# Proposed Pathways Cremorne Seniors Housing: SSD49472213

Submission to the Independent Planning Commission  
Dr Alison Ziller

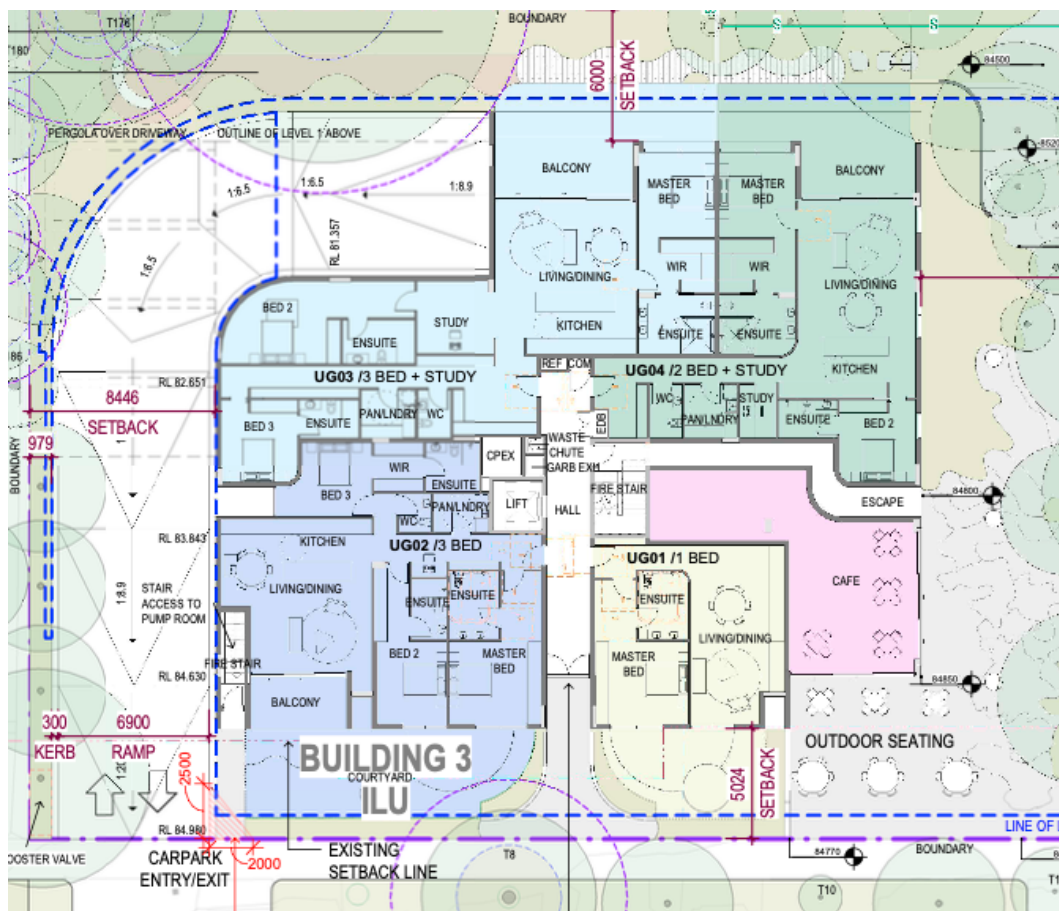
The Acoustic studies have failed to address the risk of noise experienced by occupants of residential buildings near the RACF. The original acoustic report by Pulse White Noise Acoustics P/L did not consider the question of noise from roof top condensers providing air conditioning to the RACF, or any other, building. Indeed it states, Appendix I p 34, that the exact locations of key plant items “have not been selected” and it goes on to assume that condensers would be installed on apartment balconies. This assumption does not apply to the RACF and may be incorrect for the other buildings. The GYDE Amendment Report does not mention air conditioning and thus does not provide any information about this issue.

Further, the stamped plans show provision for ‘plant’ at the top of all buildings. As ‘plant’ is unspecified, the author of the updated acoustic report should have identified these items and their noise potential. Appendix G does not do this.

However, these recommendations do not address noise from a roof top air conditioning system that operates 24/7. Noise from this source is a potential social impact issue for nearby residents, for example residents of 81A and 81B Gerard Street. Glazing requirements for the proposed buildings do not address this issue for residents of other buildings. Glazing is not a suitable remedy for residential buildings because it means windows must be kept closed. Unremitting noise is a serious health hazard.

The acoustic reports submitted to DPHI do not deal with the air conditioning realities of the buildings' designs as submitted for approval. This means that their acoustic impacts, including the social impacts of likely acoustic effects of roof top condensers, have not been adequately assessed.

Architectural Drawing 3 of 14: lower ground floor

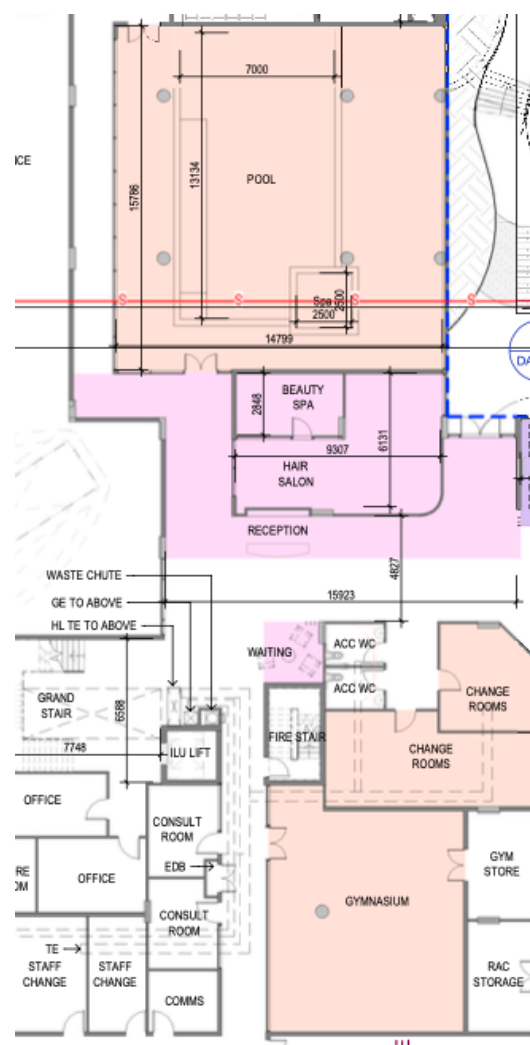
For example, it is unclear whether the proposed pool is just a pool or is intended to be suitable for hydrotherapy rehabilitation/exercise for older people and people with a disability.

The change rooms are some way from the pool meaning that people would need to walk past the hair salon, reception and waiting area, in their swimwear, to get to the pool and back again to dry and change. This is likely to deter some people, including people with significant mobility impairments who might most benefit from this kind of therapeutic exercise.

No provision seems to be made for physiotherapy or other allied health services in association with pool use. While there are two consult rooms shown on the plan, these appear to be associated with office space.

However, if these services are intended to be for community use, this is not clearly specified nor well designed for such use. To begin with, they are on the lower ground floor of the RACF and the route for public access to them is unclear.

Source: Appendix B Plans - Photomontages

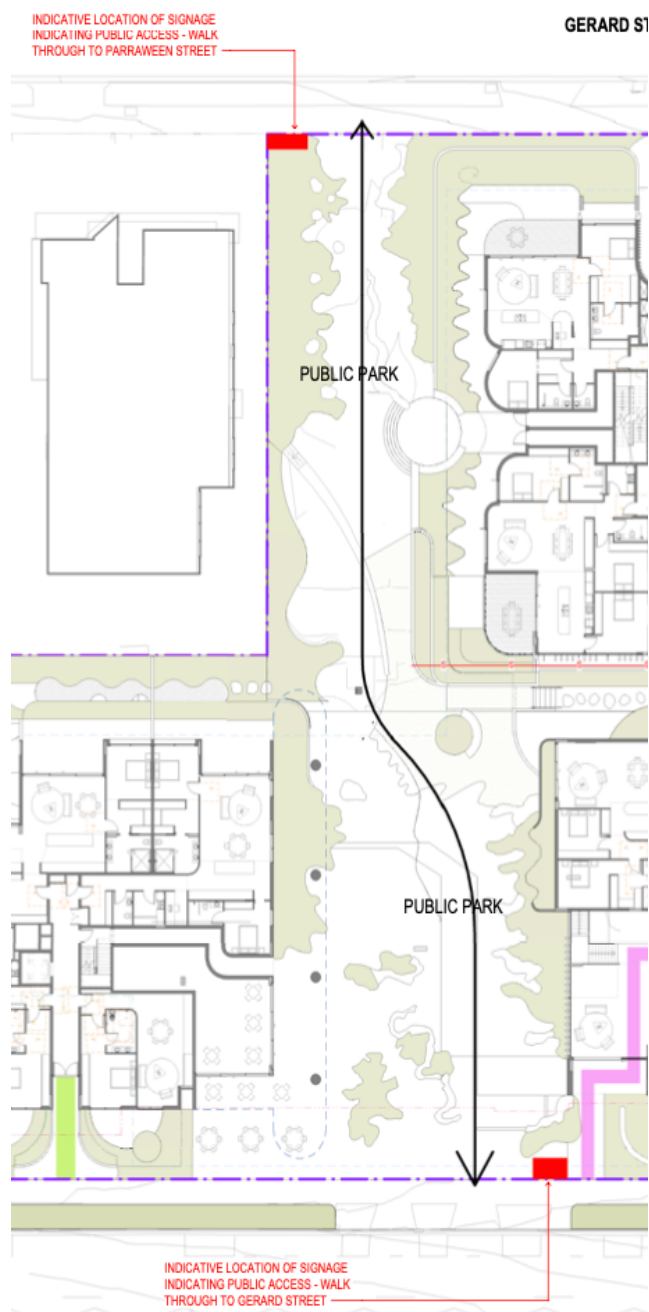
However, as a short cut between Gerard and Parraween Streets, the throughway will be inviting to cyclists and scooter riders (i.e. other than mobility scooter users) and this use will create a hazard for older residents. Similar risks apply to the public use of this throughway by dog walkers and runners. These uses are foreseeable risks for less mobile and less agile residents and are not addressed by landscaping, lighting, or distress alarms. CCTV is primarily an after-the-event monitoring device.

The proposed landscaping shown in the diagrams and photomontages suggests a reliance on paved surfaces and hard seating. It has a corporate, low maintenance look. The plans do not appear to address the outdoor needs of older or disabled residents in either the Pathways development or the local community, viz: access to outdoor seating at a suitable height with arms and back rests in quiet gardened locations, out of the wind but in the sun in winter and out of the sun in summer, and with good provision for shade on hot days and shelter from rain. The throughway seems not to provide shelter from either the wind or rain at any time of year. Specific wind mitigation measures are absent. As such it will not cater to the lived experience of ageing residents.

In sum, the configuration and design of the throughway makes it inviting for cyclists (see picture) but unsuitable for use as a recreation or ornamental area. Its proposed public use has been inadequately designed or conditioned – largely by omission.
